Access Compliance Report

Public Rights-of-Way

(Curb Ramps)

| Intersection ID: 17425 | Main Street: HAVEN_DR | Cross Street: HILLSIDE_AV | Location: SE |

| ADA ID: DCC1B95CE9D1 | Ramp Type: PerpDiag | Initial Pass/Fail: Fail | Overall Compliance: No |

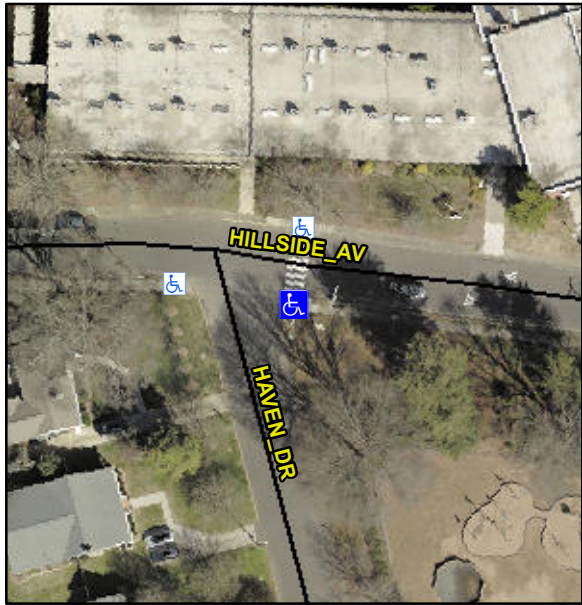
| Codes/Mitigation Info/Possible Solution | | | Field Measurements/Component Compliance | | | | | |
|--|---|-------------------------------|---|-----------------------|-------|------------|-----------------------------|-------|
| | | | No | Ramp Width (in) | 38.0 | No | Ramp XSlope (%) | 11.1 |
| PROW/ADA: | | Not Found, R304.5.1, R304.5.3 | N/A | Shared Landing? | N/A | | | |

| Codes/Mitigation Info/Possible Solution | | | Field Measurements/Component Compliance | | | | | |
|--|---|-------------------------------|---|-----------------------|-------|------------|-----------------------------|-------|
| | Remove & Replace Curb Ramp With Two New Directional Ramps or Equivalent. | | N/A | Ramp Length (in) | 56.0 | Yes | Ramp Slope (%) | 5.2 |
